Addendum 15 – UN Regulation No. 16

Revision 11 - Amendment 2

10 series of amendments – Date of entry into force: 12 June 2025

Uniform provisions concerning the approval of:

Figure 1

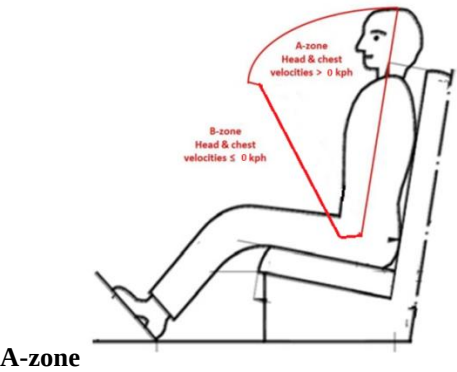
- 12. Approval granted/refused/extended/withdrawn² for fixation to the general anchorage positions as defined in Annex 6, Figure 1, to this Regulation/for use in a specific vehicle or in specific types of vehicles.⁴
- 12.1. In case a restraint system has been granted/extended approval, those can be used for particular types of vehicles compatible with the following dimensional conditions: no interior part in a quoted A-zone as shown below (Figure 1):

Arrangements of the Approval Marks

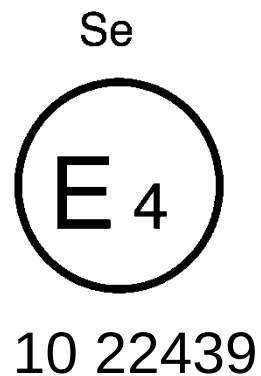
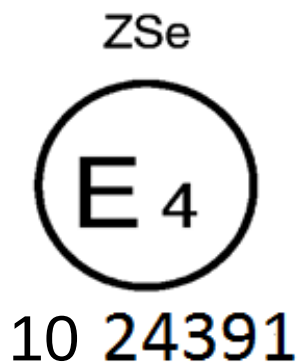
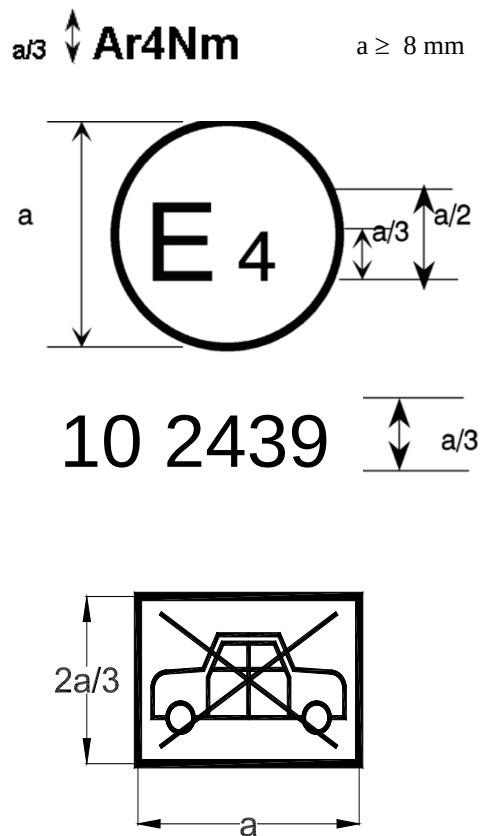
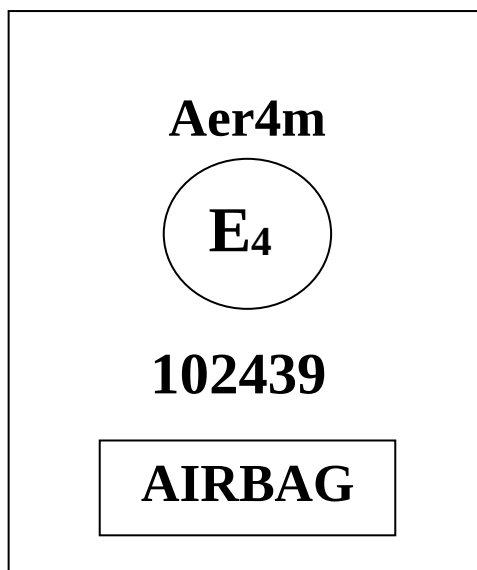
Annex 2, amend to read:

The belt bearing the above approval mark is a three-point belt ("A"), fitted with an energy absorber ("e") and approved in the Netherlands (E 4) under the number 102439, this Regulation already incorporating the 10 series of amendments at the time of approval.

The belt bearing the above approval mark is a lap belt ("B"), fitted with a retractor, type 4, with multiple sensitivity (m) and approved in the Netherlands (E 4) under the number 102489, this Regulation already incorporating the 10 series of amendments at the time of approval.

The belt bearing the above approval mark is a special type belt ("S"), fitted with an energy absorber ("e") and approved in the Netherlands (E 4) under the number 1022439, this Regulation already incorporating the 10 series of amendments at the time of approval.

The belt bearing the above approval mark is part of a restraint system ("Z"), it is a special type belt ("S") fitted with an energy absorber ("e"). It has been approved in the Netherlands (E 4) under the number 1024391, this Regulation already incorporating the 10 series of amendments at the time of approval.

The belt bearing this type approval mark is a three-point belt ("A") with a multiple-sensitivity ("m") type 4N ("r4N") retractor, in respect of which type approval was granted in the Netherlands ("E 4") under number 102439, this Regulation already incorporating the 10 series of amendments at the time of approval. This belt shall not be fitted to vehicles of category M₁.

The safety-belt bearing this type approval mark is a three-point belt ("A") fitted with an energy absorber ("e"), approved as meeting the specific requirements of paragraph 6.4.1.3.3. or 6.4.1.3.4. of this Regulation, and with a multiple-sensitivity ("m") type 4 ("r4") retractor, in respect of which type approval was granted in the Netherlands ("E 4") under the approval number 102439. The first two digits indicate that the Regulation already incorporated the 10 series of amendments at the time of the approval. This safety-belt has to be fitted to a vehicle equipped with an airbag in the given seating position.
